Title		PIXRACER-V1-FMU	AUAV.CO
Size	Number	DEC-06-2015-1330	Revision
A4			RC12
Date:	17.03.2016	Sheet of	3 of 5
File:	F:\fwdsch\PIXRACER-FMU-R14.SchDoc	Drawn By:	Nick Arsov

Title		PIXRACER-V1-IMU		AUAV.CO	
Size	Number	JAN-21-2016-2130		Revision	RC14
Date:	17.03.2016	Sheet of	5 of 5		
File:	F:\fwdsch\PIXRACER-IMU-R14.SchDoc	Drawn By:	Nick Arsov

Title		PIXRACER-V1-POWER		AUAV.CO	
Size	Number	JAN-21-2016-2130		Revision	
A4				RC14	
Date:	17.03.2016	Sheet of	1 of 5		
File:	F:\fwdsch\PIXRACER-POWER-R14.Sch	Drawn By:	Nick Arsov

Title		PIXRACER-V1-SERIALS		AUAV.CO	
Size	Number	JAN-21-2016-2130		Revision	RC14
A4					
Date:	17.03.2016	Sheet of	2 of 5		
File:	F:\fwdsch\PIXRACER-SERIALS-R14.Sch	Drawn By:	Nick Arsov

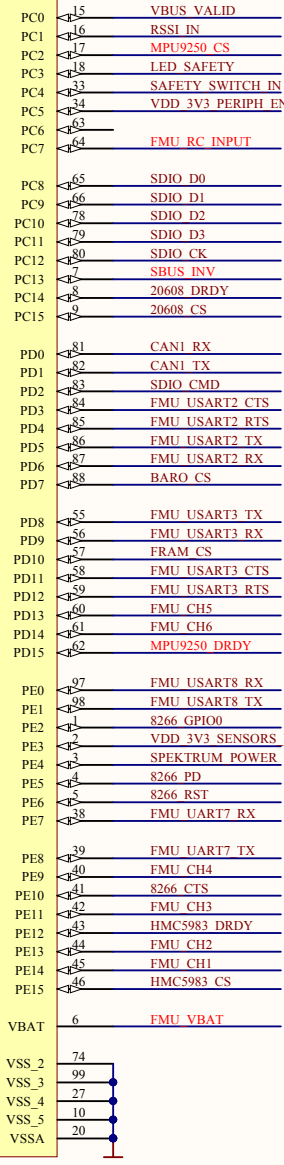
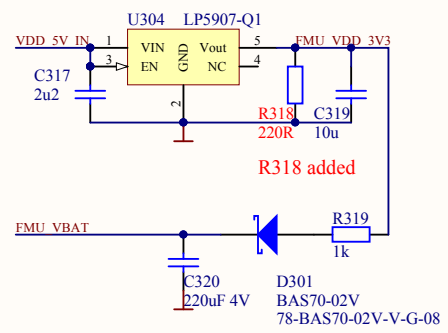
PB0 is separated from PC7

8266 GPIO2 added here BRICK_VALID is now Active HIGH

VBUS_VALID is now Active HIGH

PC7 is separated from PB0

SBUS inverted with active HIGH (U1203)

D301,R319,C320 added

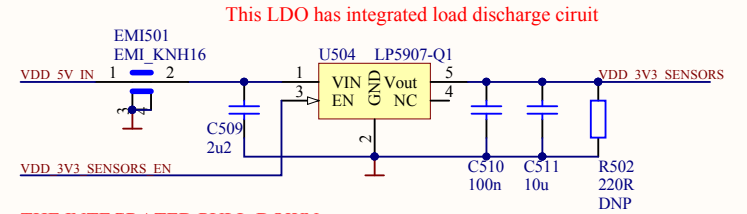
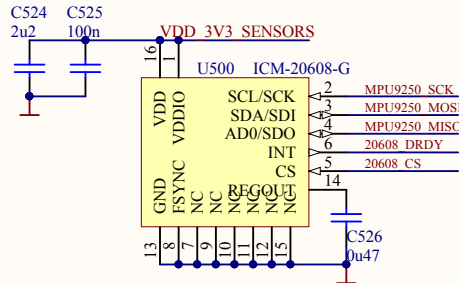
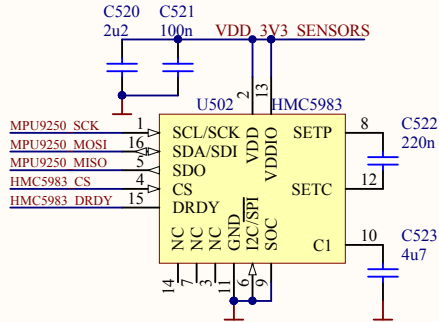
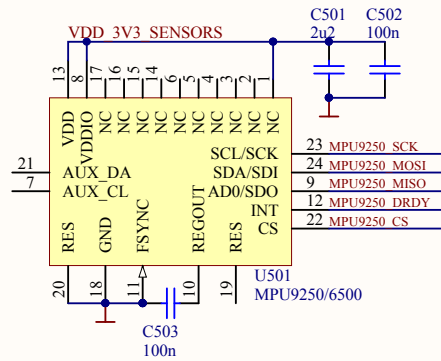
BARO SPI moved to FRAM SPI

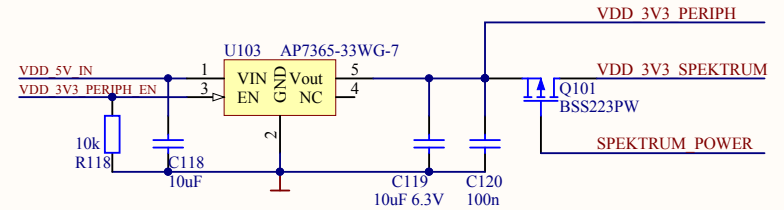
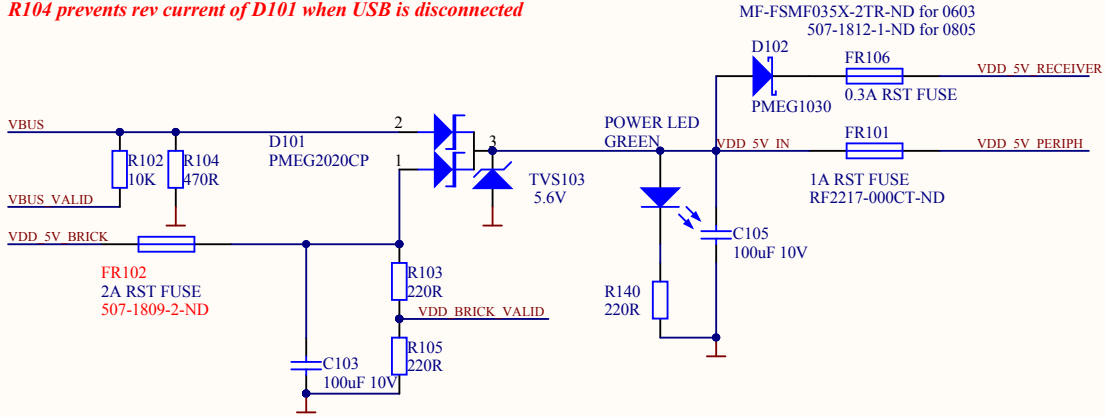
R104 prevents rev current of D101 when USB is disconnected

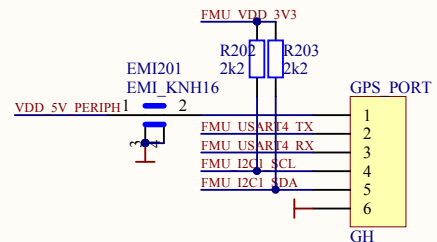
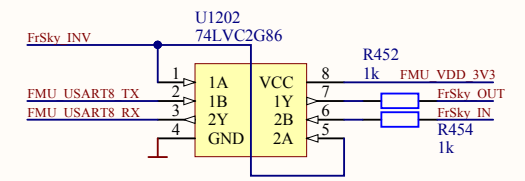
*U1203 and R200 (DNP) footprints are left as is, thus the stencils won't be changed
 R200 will not be soldered, and U1203 and U1202 are left the same for lower price
 A 14V TVS could be soldered instead R200 just in case*
